## **APPENDIX I-6**

**AECOM Memo**  
*September 16, 2020*

**Date:** 9/16/2020  
**To:** IHCC Files  
**From:** David M. Cregger, P.E. (NY), P.G. (NY)  
**Subject:** Update of Landslide Soils Properties

Figure 1. Topographic Profile along Three Borings

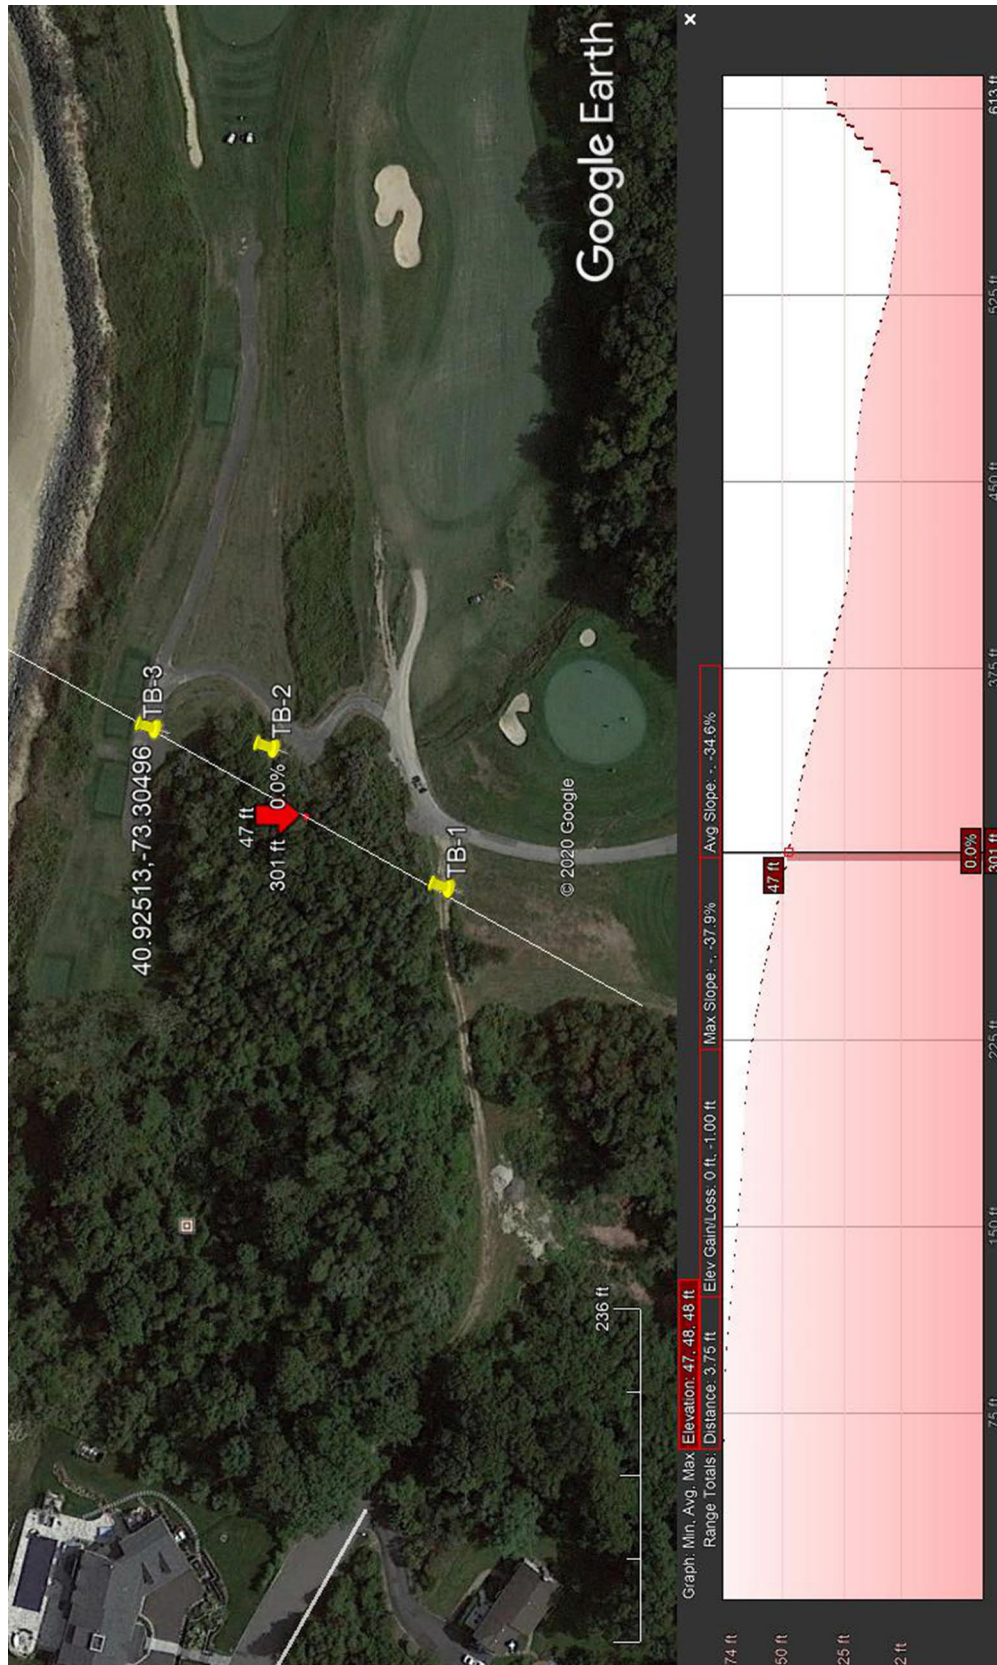
Based on the new data from 3 borings shown on Figure 1 and lab tests, we reduced the cohesion of the Gardiners clay deposit from 650 psf to 500 psf in our simplified analysis and raised the water table to approximate Elevation +50 in the pre-existing landslide area. This conservative approach indicates a Factor of Safety greater than 1.3 as we previously recommended with the 300 psf surcharge of the buildings.

Figure 2. Possible New Scarp North of TB-1

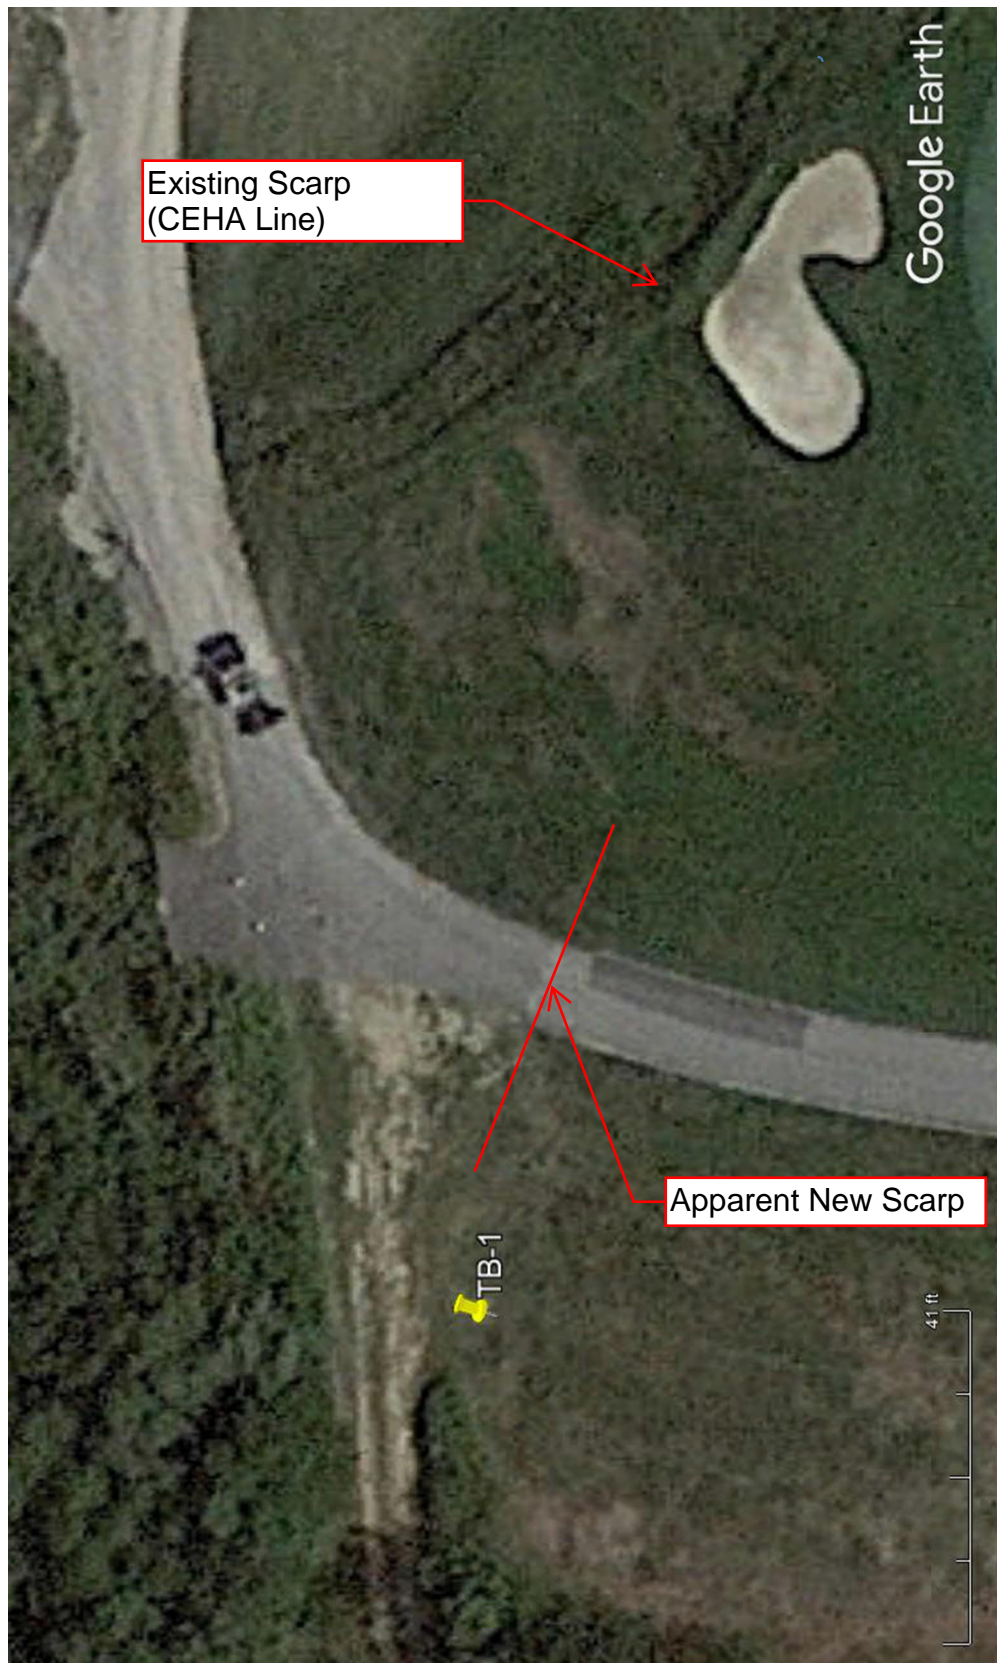
Considering the new data provided, we now conclude that 120 feet may be enough of a buffer *provided the hydrology and shoreline conditions outside the Coastal Erosion Hazard Line do not change*. A possible new scarp is visible on recent Google Earth imagery between borings TB-1 and TB-2 as shown on Figure 2 where the golf cart path is damaged. Continued survey deformation monitoring at the golf course is recommended.
